RE: Docket ID No. EPA-HQ-OAR-2002-0058
National Emissions Standards for Hazardous Air Pollutants for Major Sources:
Industrial, Commercial, and Institutional Boilers and Process Heaters
75 Fed. Reg. 32006

Comments of the International District Energy Association

National Emissions Standards for Hazardous Air Pollutants for Major Sources: Industrial, Commercial, and Institutional Boilers and Process Heaters (Docket ID No. EPA-HQ-OAR-2002-0058)

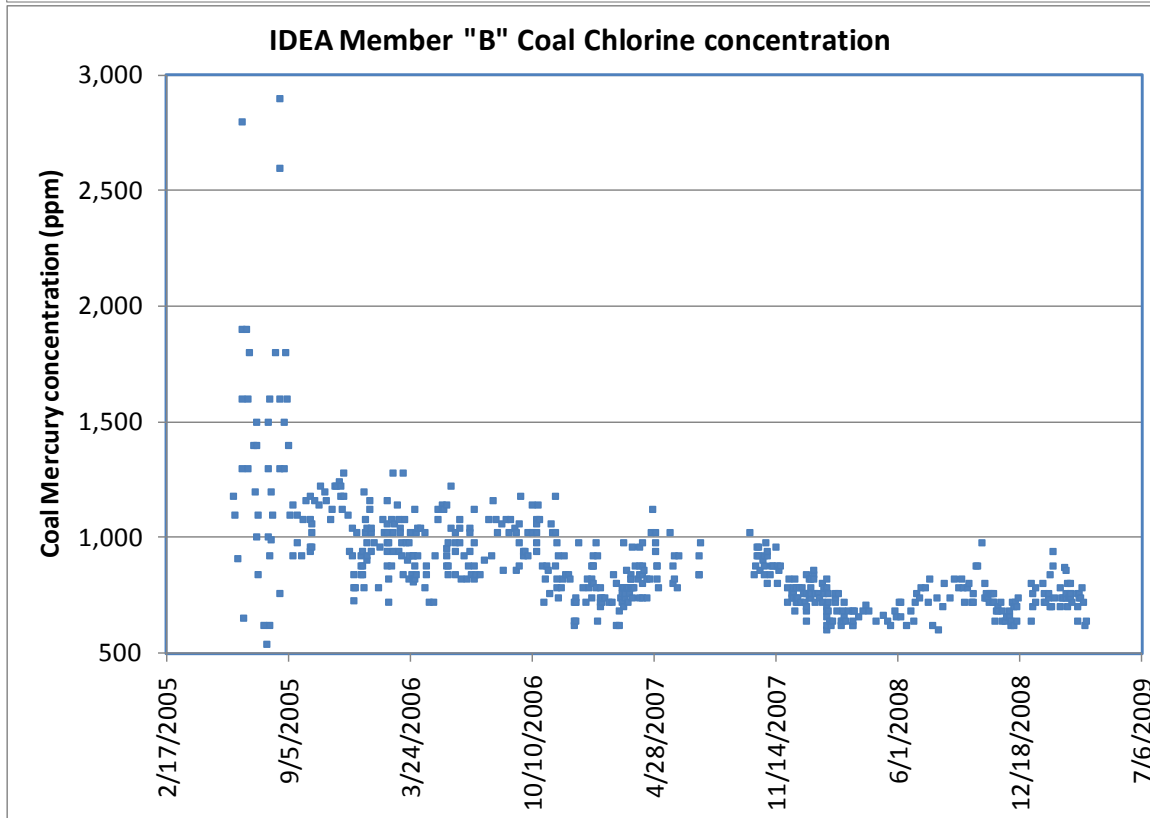
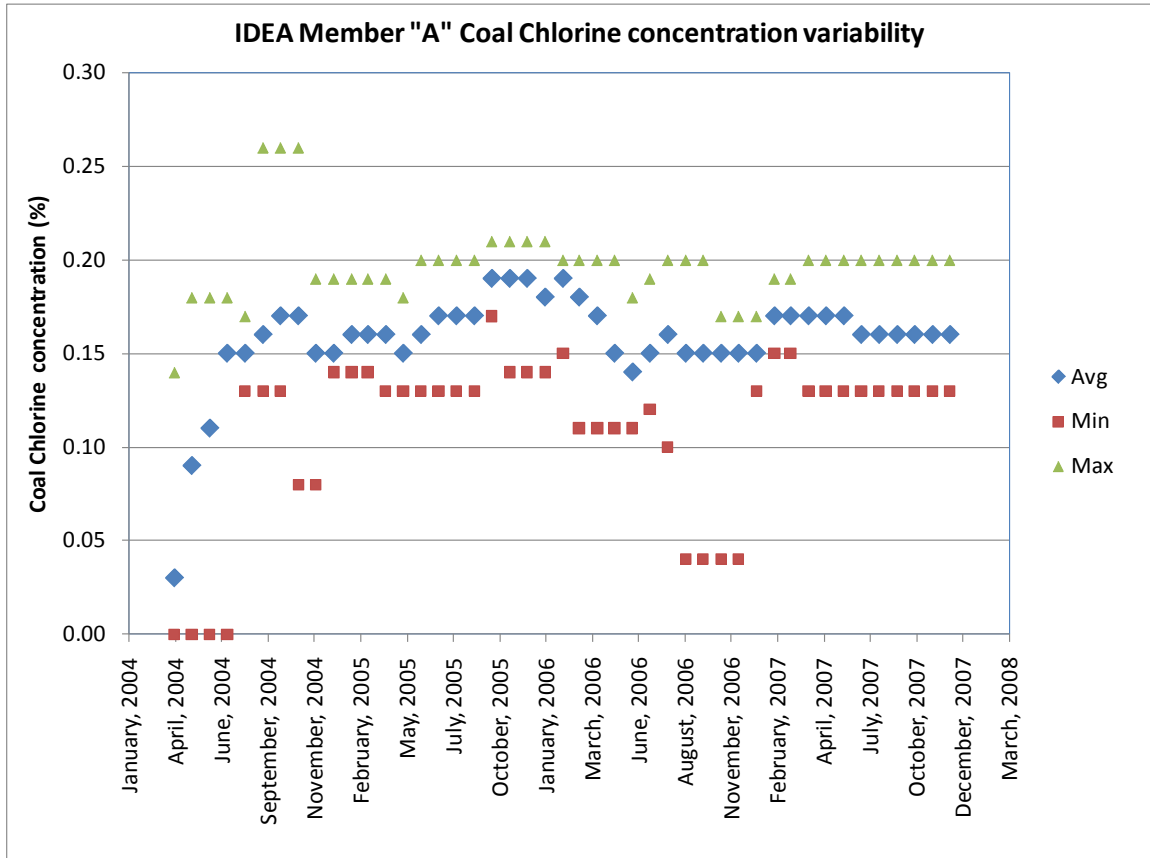
The significant variability in mercury and chlorine concentrations found in power plant coal in 1999 is consistent with more recent results from sampling of coal used in IDEA member facilities that would likely be subject to the Boiler MACT rule. Below are graphs of coal mercury and chlorine concentrations in for two IDEA members operating coal-fired facilities.

IDEA requests that the EPA gather additional data and further consider the impact of solid fuel variability with respect to the Boiler MACT Rule compliance requirements.
